Access Compliance Report Public Rights-of-Way (Curb Ramps)

Main Street: RIBERA_RD		Cross Street: ASCENSO_AVE		Location:	SW
ADA ID: RPRK211117170252	Ramp Type: Type 1 - Perpendicular	Initial Pass/Fail: Pass	Overall Compliance: No	Severity Score:	5
Codes/Mitigation Info/Possible Solution			Field Measurements/Component Compliance

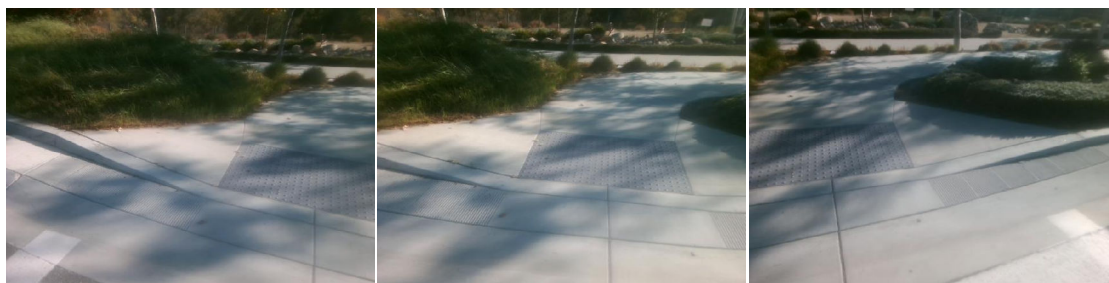
R304.5.4, R304.5.3, STD 1115

Remove & Replace Gutter.
